## **Falcon Highlands Filing No. 3**

### **Master Development Drainage Plan**

**March 18, 2022**

**SKP-21-004**

JOB: 21000656  
SHEET NO. 1  
EX-01

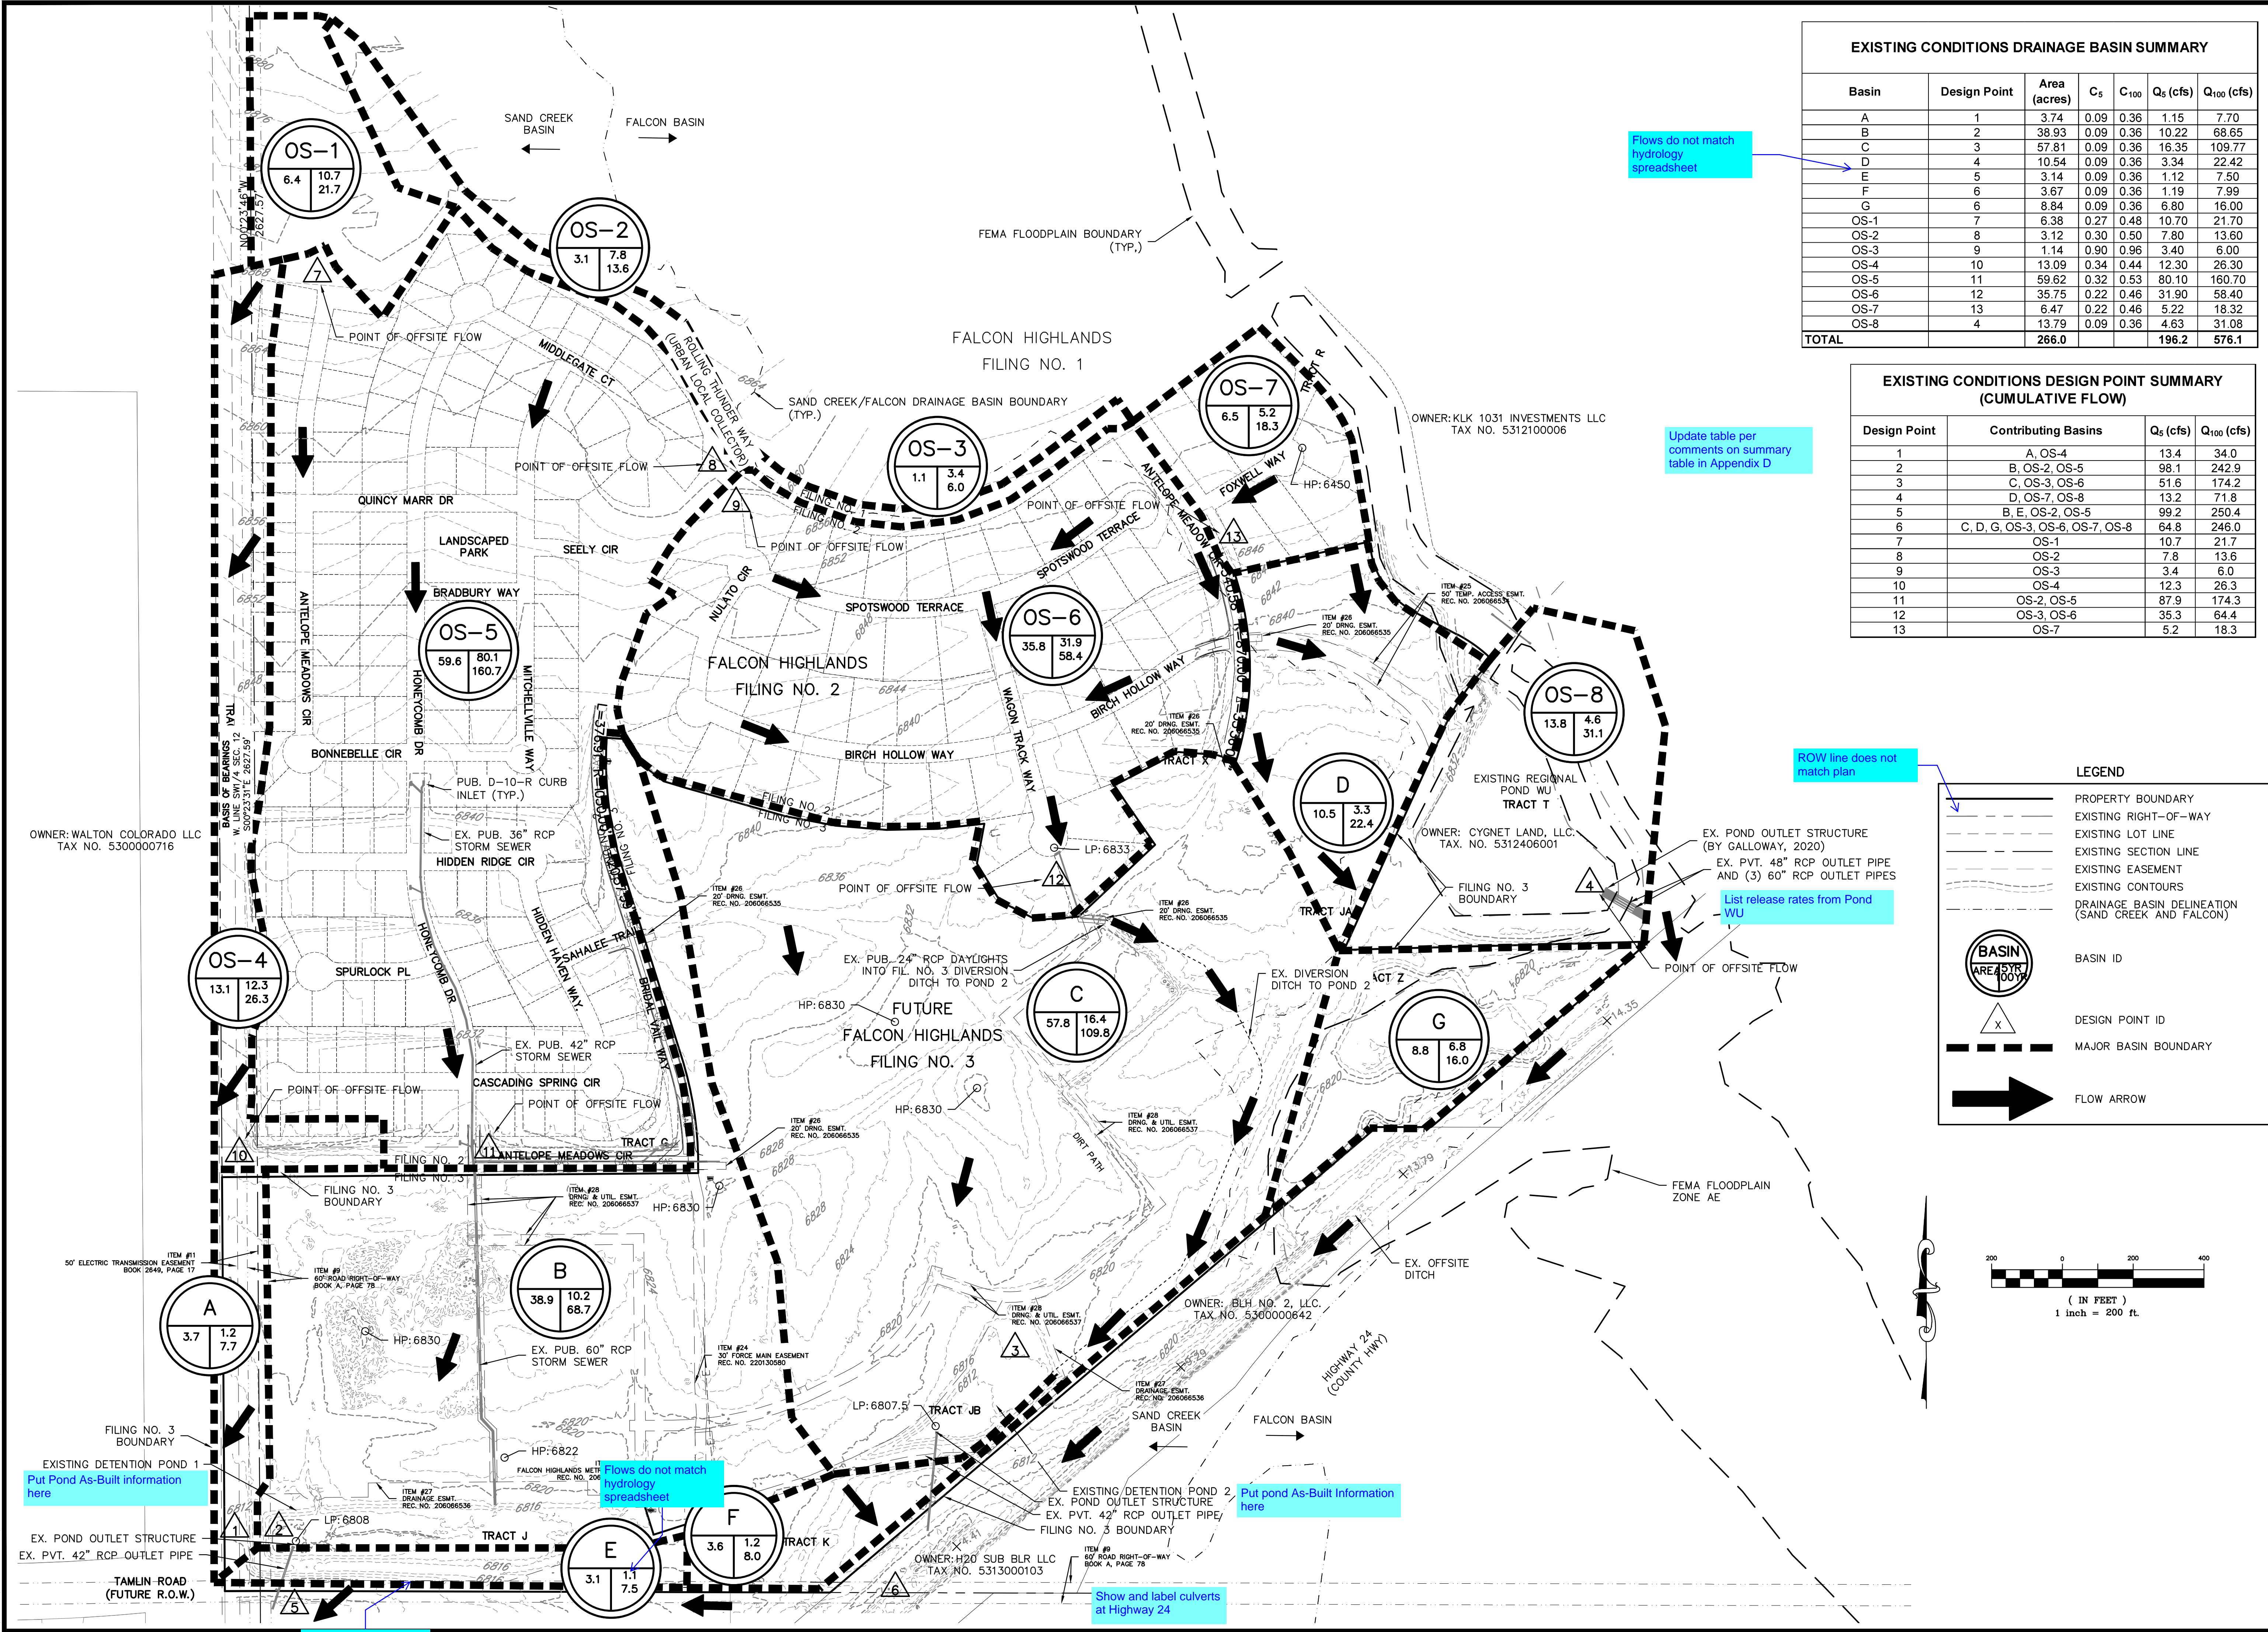
Flows do not match hydrology spreadsheet

ROW line does not match plan

Show and label culverts at Highway 24

Label existing area inlet

Update table per comments on summary table in Appendix D

JOB: 21000656  
SHEET NO. 1  
EX-02

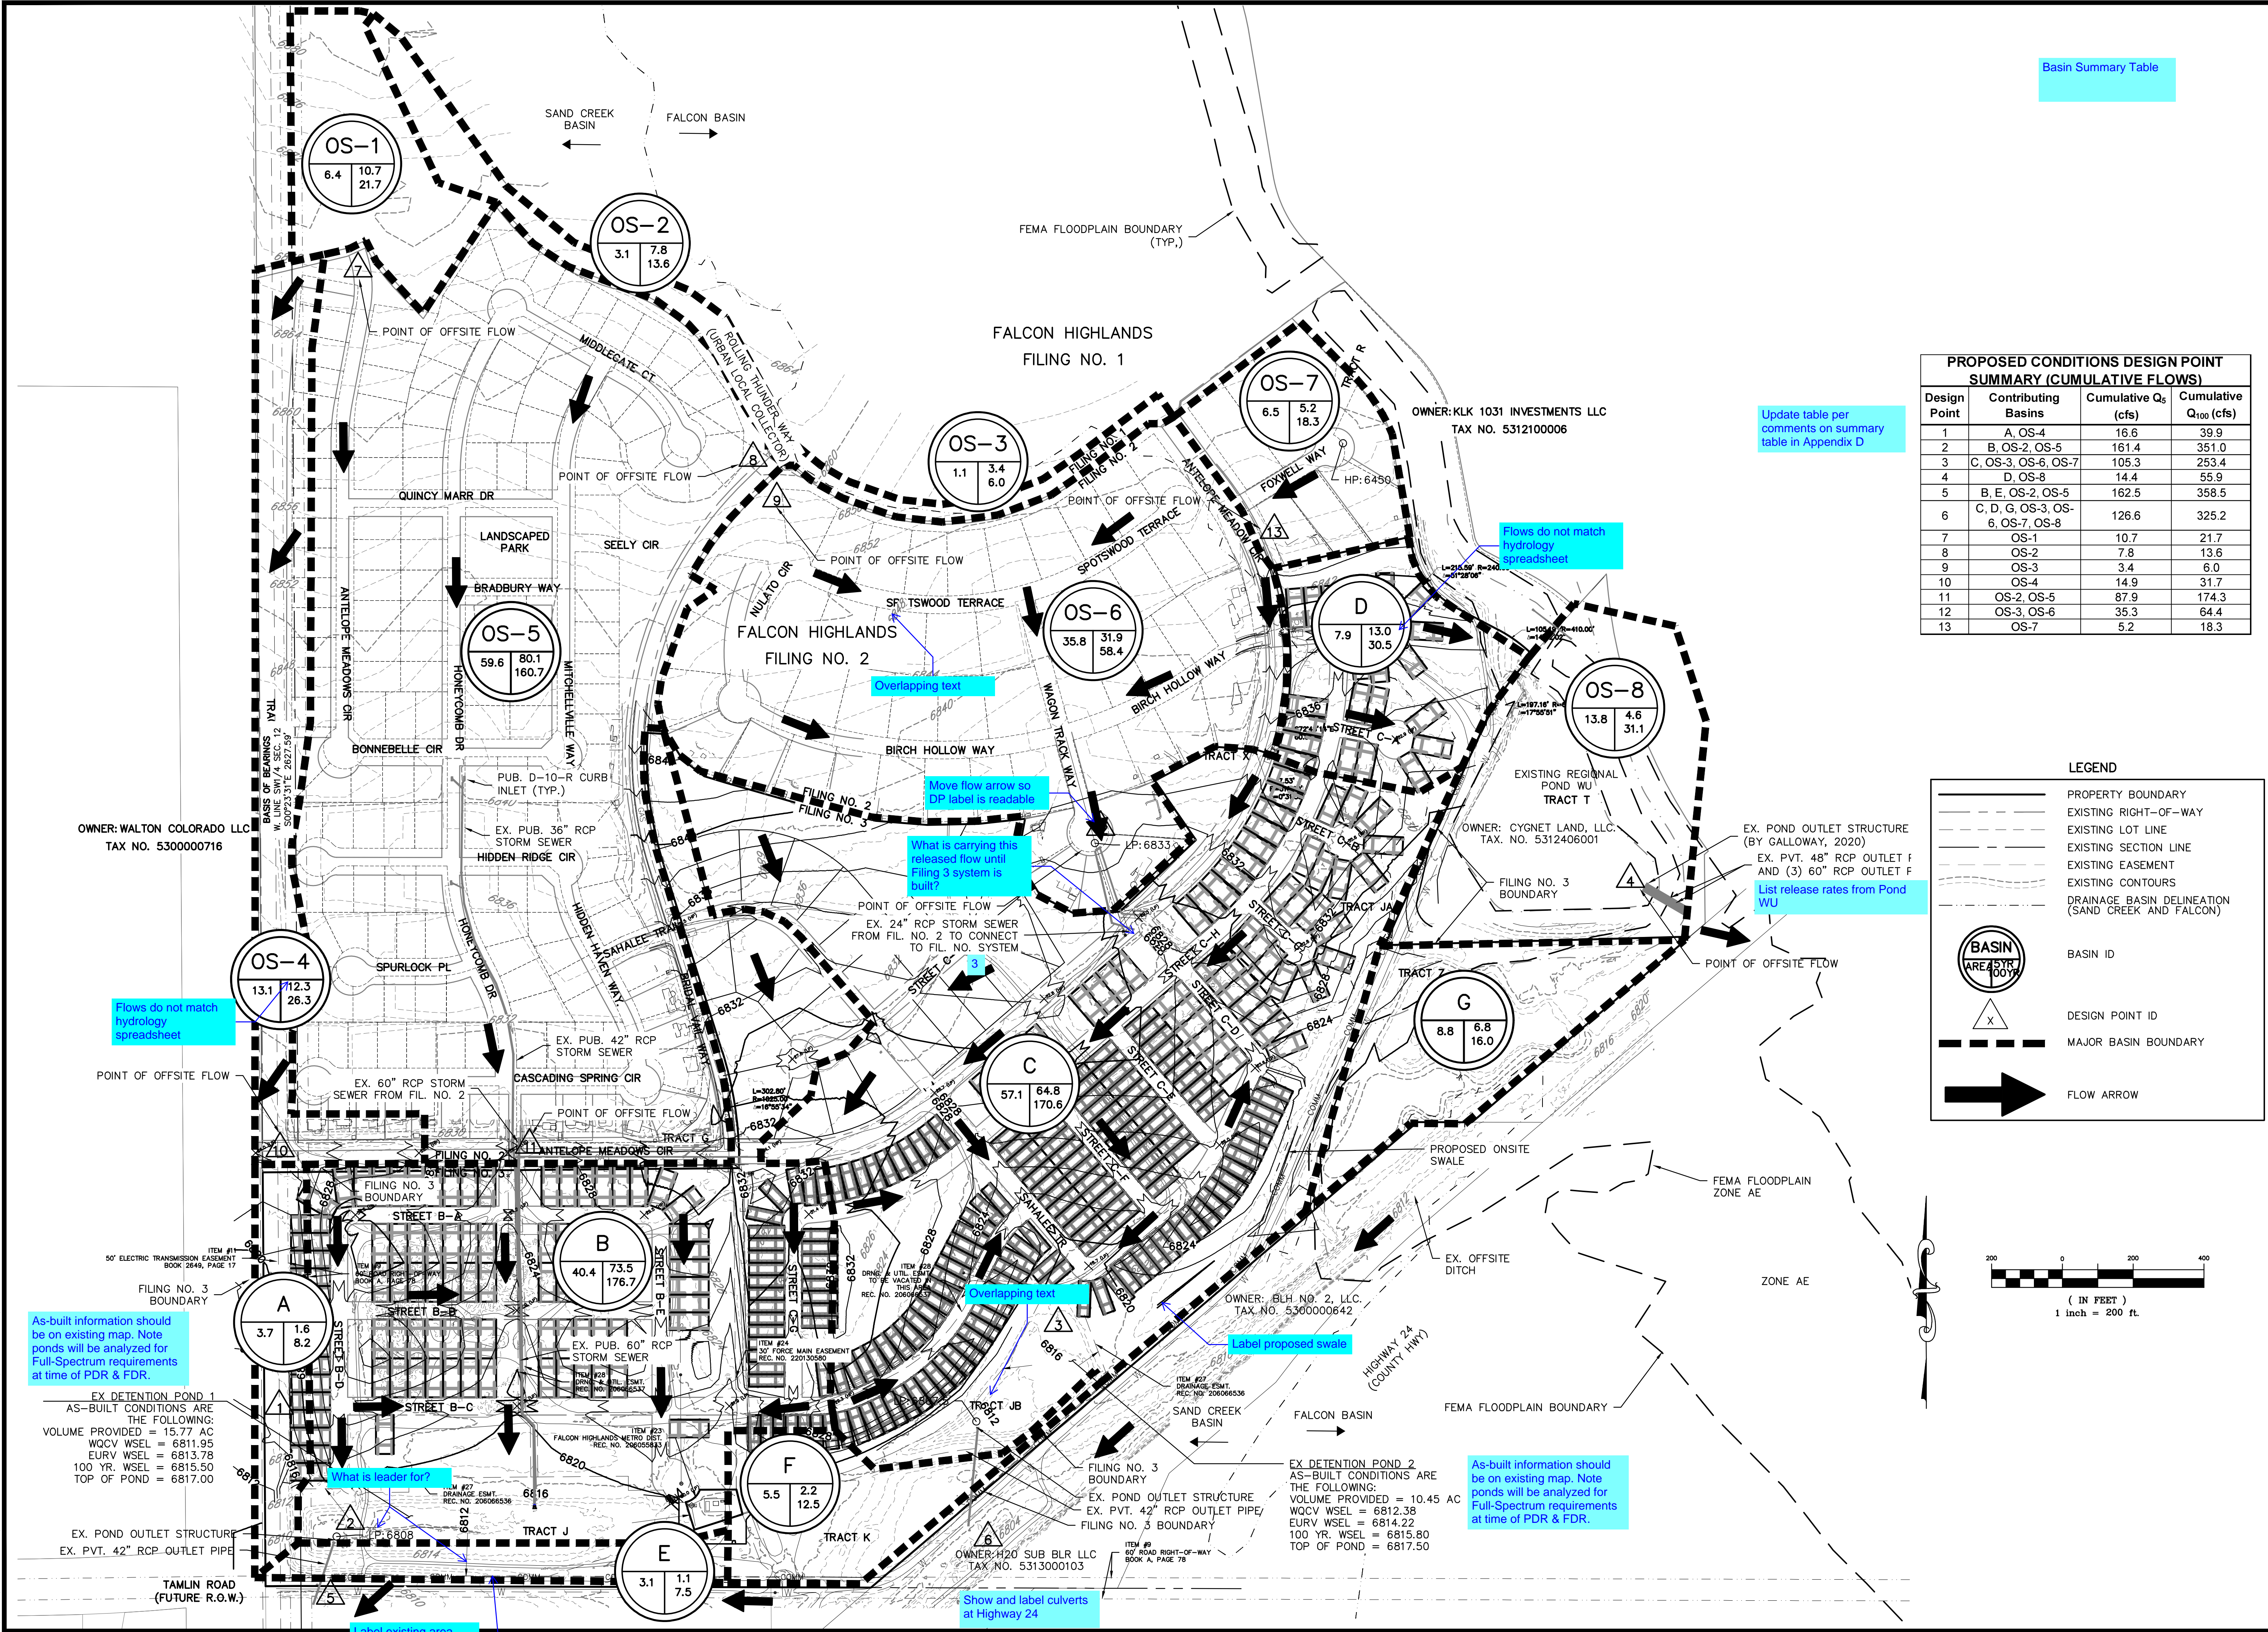
Show and label culverts at Highway 24

Show and label culverts at Highway 24
